9.3 NO. 3 (LOT: 43; D/P: 1237) ALMA ROAD MOUNT LAWLEY - PROPOSED GROUPED DWELLING (AMENDMENT TO APPROVED)

1. Consultation and Location Map
2. Final Development Plans
3. Approved Plans - Determined by Council 30 April 2019

To consider an application to amend development approval for a grouped dwelling at No.3 Alma Road, Mount Lawley (subject site).

FF
 A104
 FIRST FLOOR PLAN

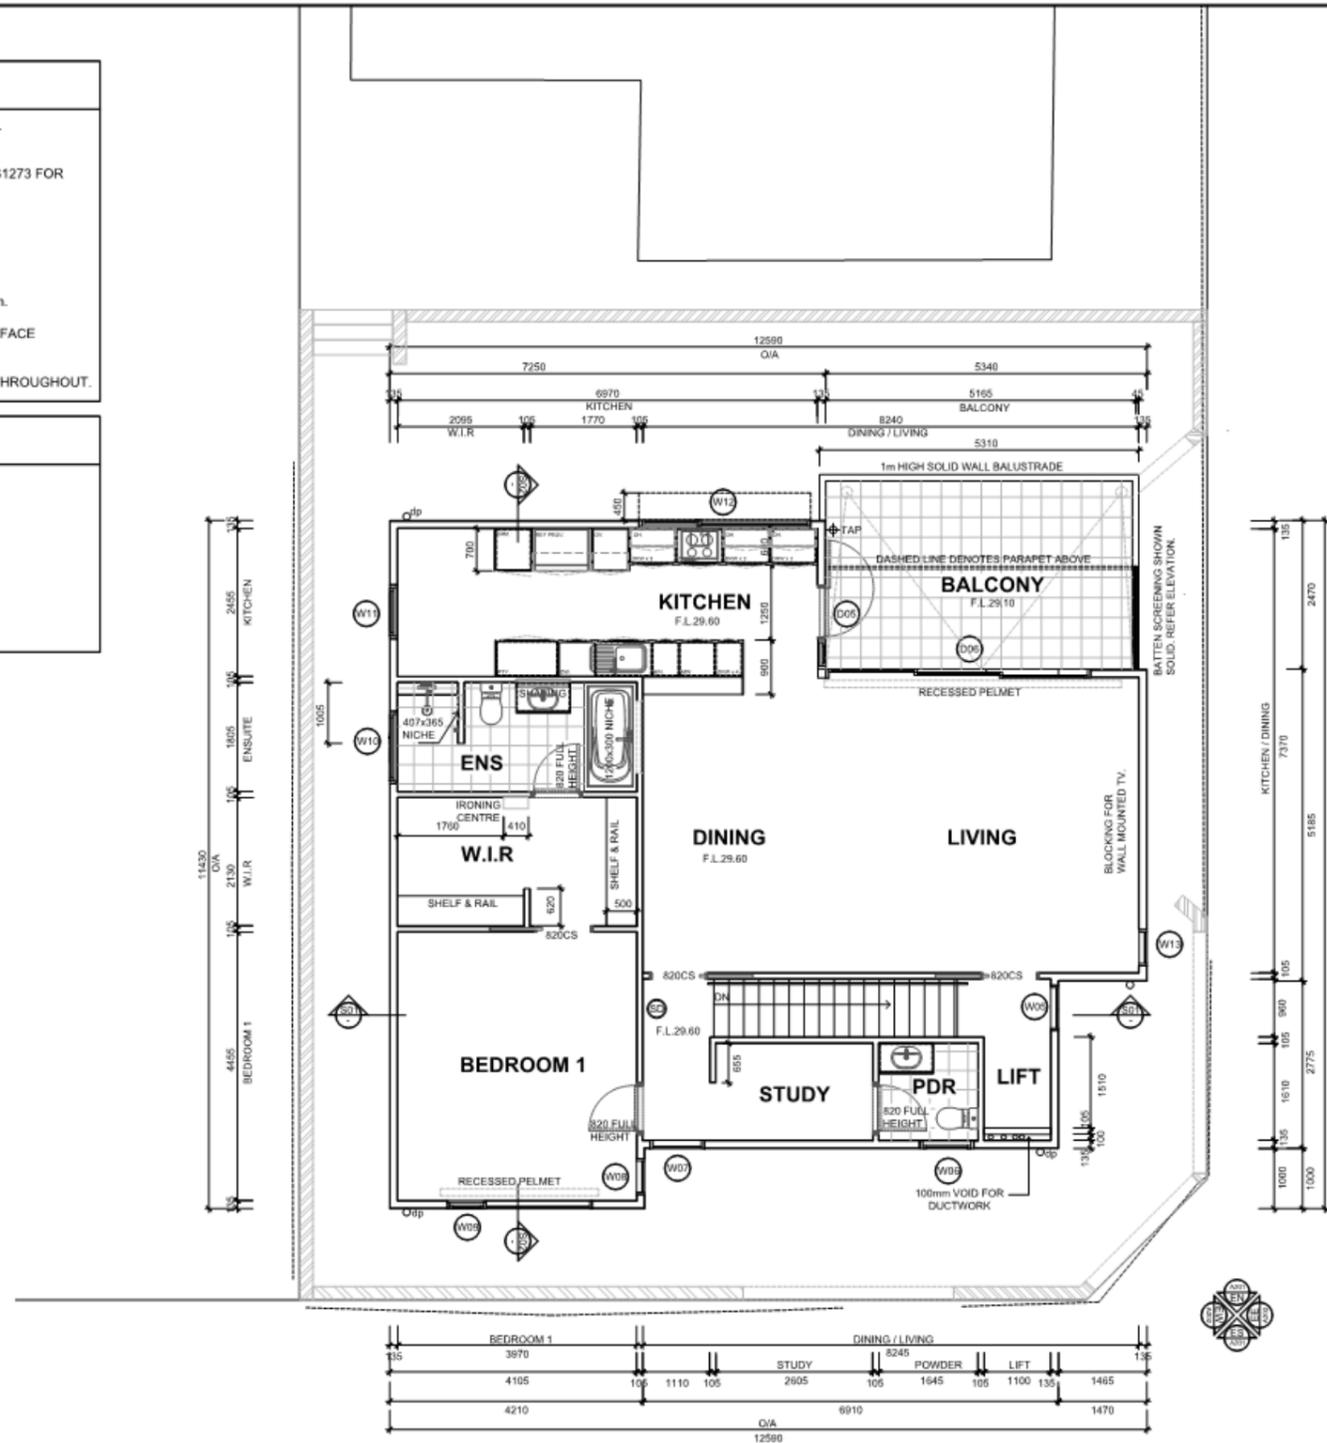
The proposed removal of the roof terrace through this application would result in the balcony on the first floor becoming the primary outdoor living area, resulting in new departures to the deemed-to-comply standards of the R Codes.

The balcony would result in an outdoor living area with a 3.6 metre minimum dimension and 9.9 square metres without permanent roof cover. The application does not propose any change to the size or design of this balcony area from the previous approval.

- **Size:** The 3.6 metre width of the outdoor living area is compensated by the length of 5.7 metres. The dimensions of the balcony enable the space to be a usable extension of the habitable rooms. The balcony is 20.4 square metres in area, satisfying the minimum 20 square metres deemed-to-comply standard;

- **Weather protection:** The 10.5 square metre covered portion of the balcony would support the use of the space all year round. The remainder of the balcony is open to allow for sufficient access to sunlight and ventilation to the dwelling and its occupants, enhanced by the northern aspect of the balcony; and

FIRST FLOOR PLAN AND
ROOF GARDEN

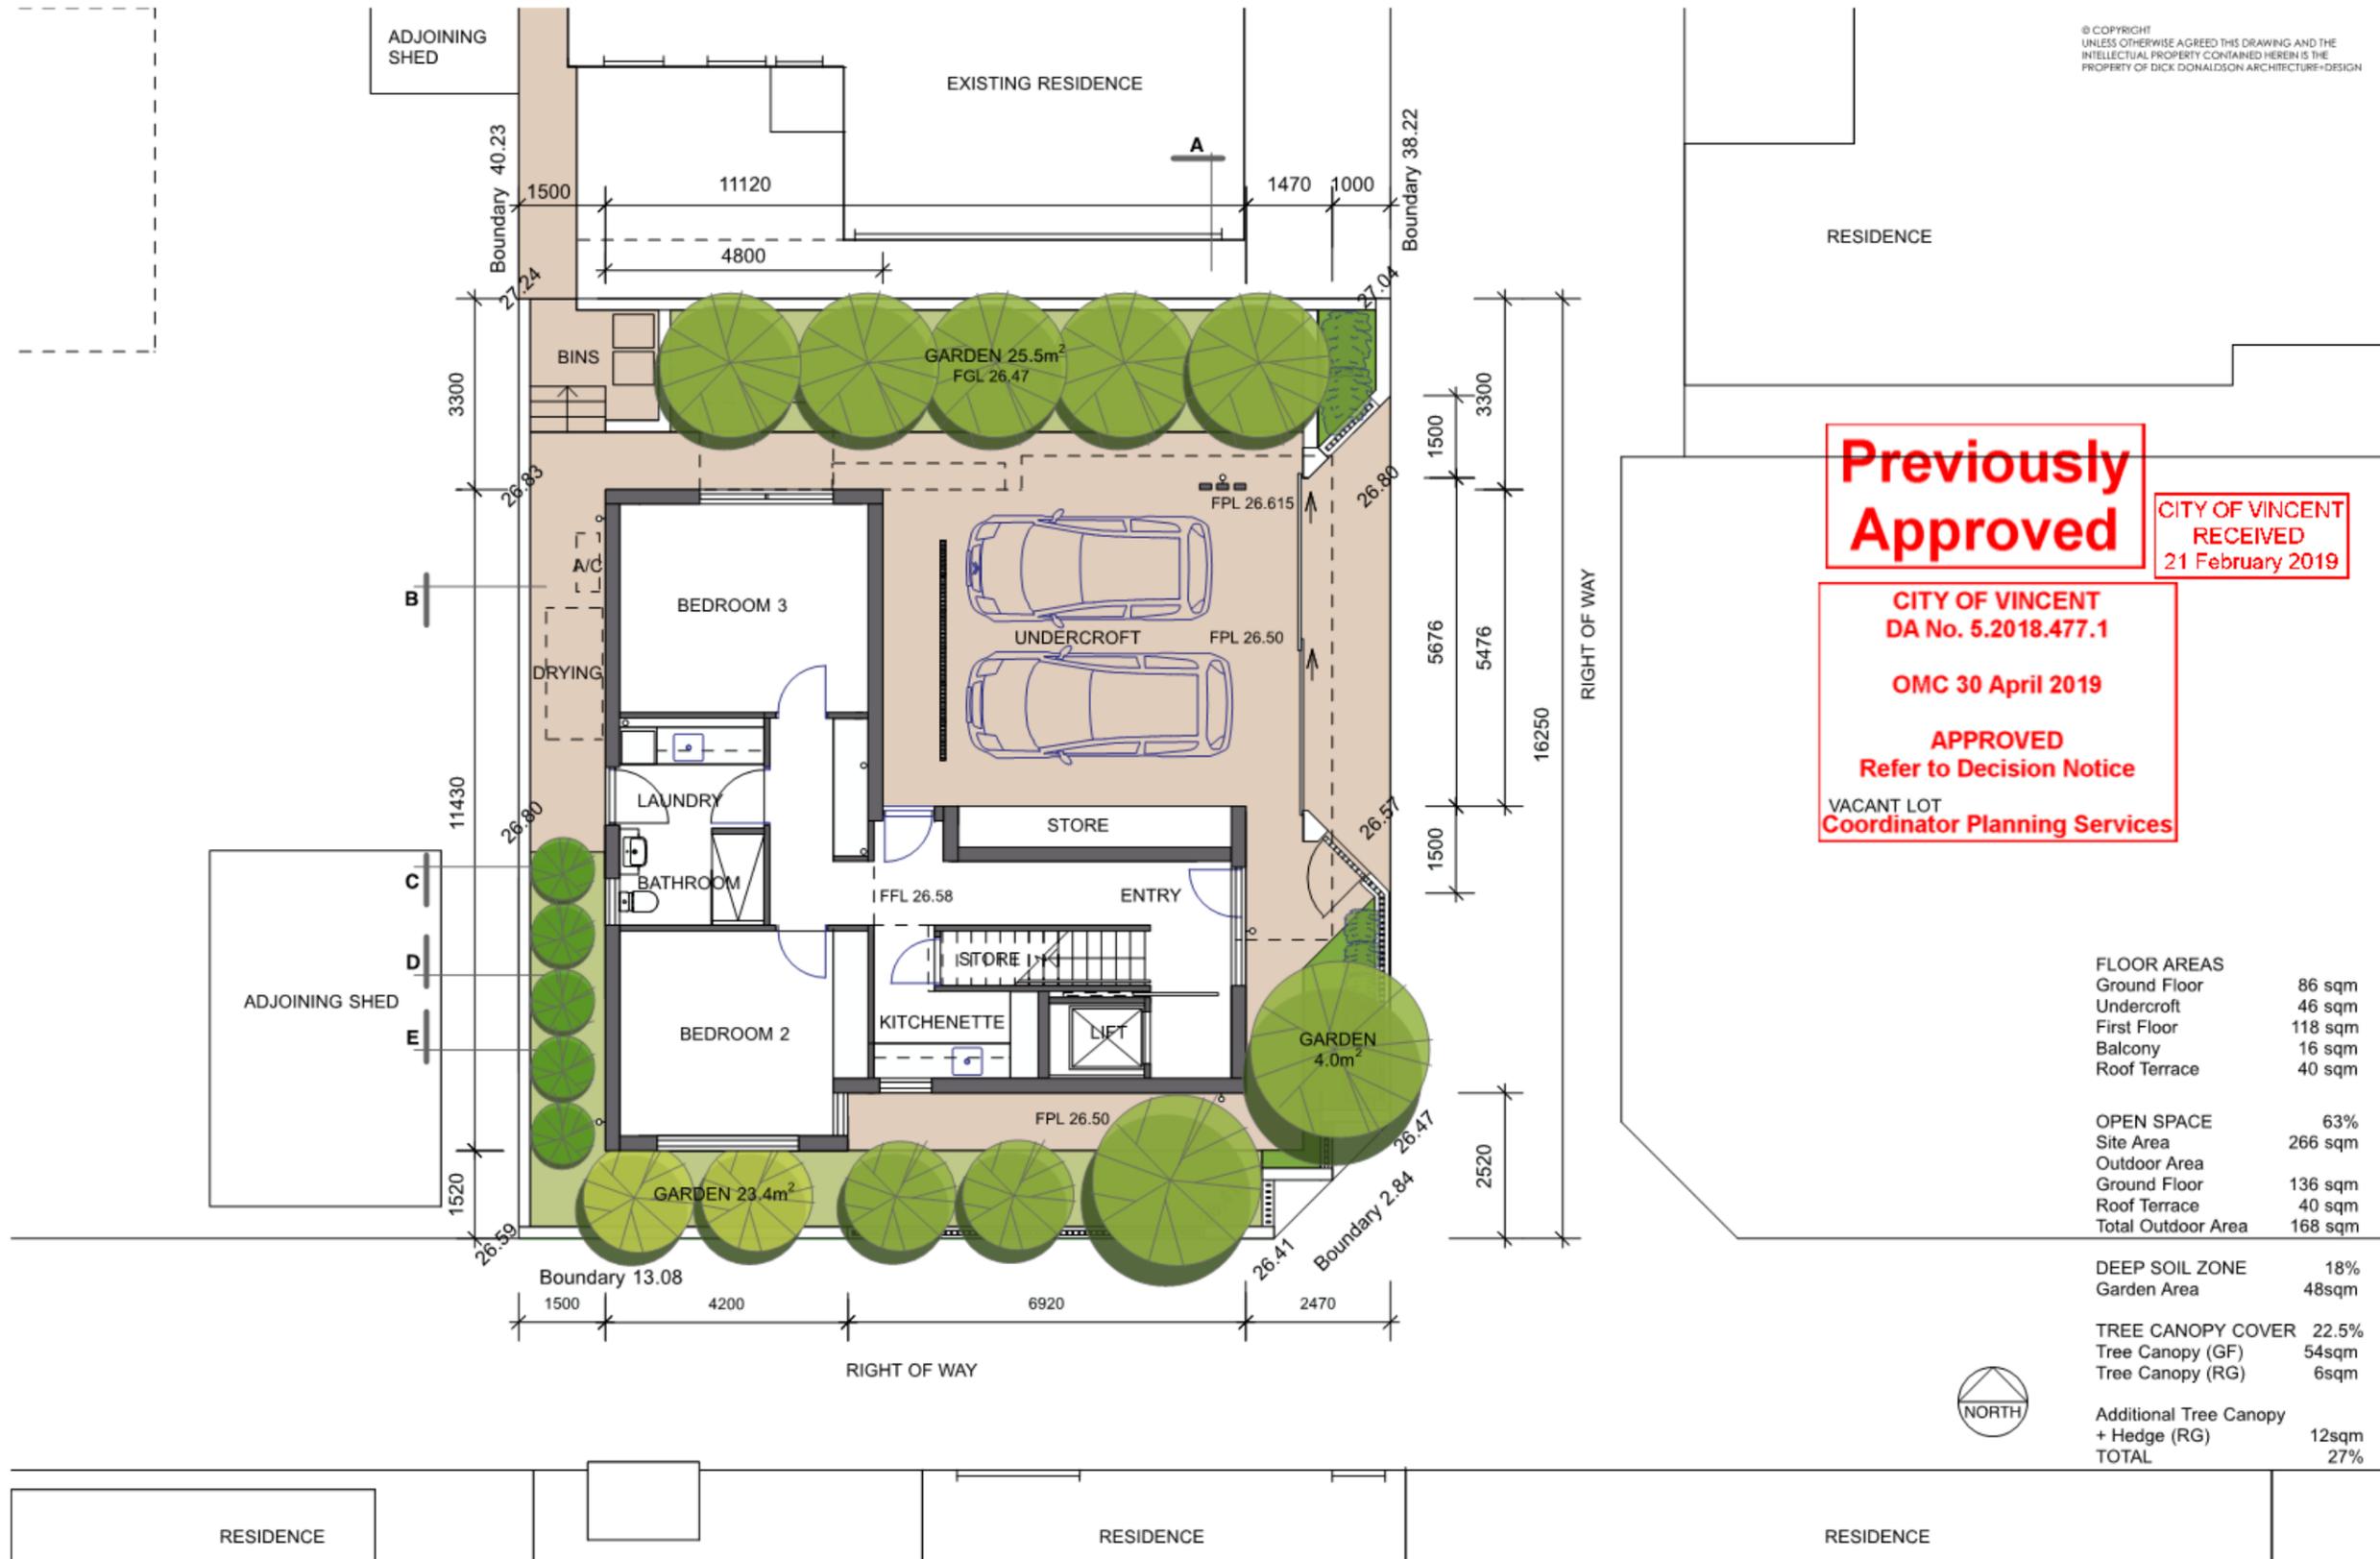
The previous approval included the imposition of Condition 6.3 requiring fixed planters boxes to be provided along the western length of the roof terrace. This was required to provide adequate privacy screening to restrict overlooking in accordance with the R Codes.

The roof terrace of the dwelling is proposed to be removed and so this condition is no longer required. The planter boxes also did not contribute to deep soil area and canopy cover due to their size so it would not reduce the amount of deep soil area and canopy cover on the site.

1. All conditions, requirements and advice notes detailed on the development approval 5.2018.477.1 granted on 30 April 2019 continue to apply to this approval, except as follows:
 - 1.1 Condition 6.3 is deleted.
